## PCI-SIG ENGINEERING CHANGE NOTICE

<b>TITLE:</b>	VF Resizable BARs
<b>DATE:</b>	July 6, 2016
<b>AFFECTED DOCUMENT:</b>	Single Root I/O Virtualization and Sharing Specification version 1.1, PCI Code and ID Assignment Specification version 1.7
<b>SPONSORS:</b>	Advanced Micro Devices

**Figure 7-x4 VF Resizable BAR Control Register**

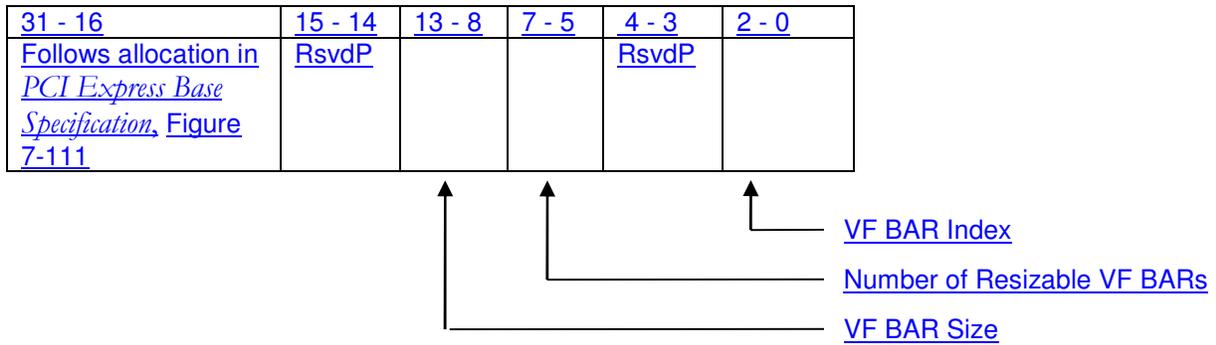
### **7. xx.3. VF Resizable BAR Control Register (Offset 08h)**

The VF Resizable BAR Control register bits 31:16 follow the same definitions as the Resizable BAR Control register in *PCI Express Base Specification*, Table 7-97.

<u>Bit Location</u>	<u>Register Description</u>	<u>Attributes</u>
<u>2:0</u>	<p><b><u>VF BAR Index</u></b> – This encoded value points to the beginning of this particular VF BAR located in the SR-IOV Capability.</p> <p>0 = VF BAR located at offset 24h  1 = VF BAR located at offset 28h  2 = VF BAR located at offset 2Ch  3 = VF BAR located at offset 30h  4 = VF BAR located at offset 34h  5 = VF BAR located at offset 38h  All other encodings are reserved.</p> <p>For a 64-bit Base Address register, the VF BAR Index indicates the lower DWORD.</p> <p>This value indicates which VF BAR supports a negotiable size.</p>	<u>RO</u>
<u>7:5</u>	<p><b><u>Number of VF Resizable BARs</u></b> – Indicates the total number of resizable VF BARs in the capability structure for the Function. See Figure 7-x1.</p> <p>The value of this field must be in the range of 01h to 06h. The field is valid in VF Resizable BAR Control register (0) (at offset 008h), and is RsvdP for all others.</p>	<u>RO/RsvdP</u>

<u>13:8</u>	<p><b><u>VF BAR Size</u></b> – This is an encoded value.</p> <p>0 = 1 MB (<math>2^{20}</math>)  1 = 2 MB (<math>2^{21}</math>)  2 = 4 MB (<math>2^{22}</math>)  3 = 8 MB (<math>2^{23}</math>)  ...  43 = 8 EB (<math>2^{63}</math>)</p> <p>The default value of this field is equal to the default size of the address space that the VF BAR resource is requesting via the VF BAR's read-only bits.</p> <p>Behavior is undefined if a value is written in this field and the corresponding supported size bit is not Set in the VF Resizable BAR Capability or VF Resizable BAR Control registers.</p> <p>When this register field is programmed, the value is immediately reflected in the size of the resource, as encoded in the number of read-only bits in the VF BAR.</p>	<u>RW</u>
<u>31:16</u>	<p>The descriptions for these bits are the same as the definitions in the Resizable BAR Control register in <i>PCI Express Base Specification</i>, Table 7-97. Where those descriptions say 'BAR', this register's description is for 'VF BAR'. Where those descriptions say 'Function', this register's description is for 'PF'.</p>	From <i>PCI Express Base Specification</i> , Table 7-97
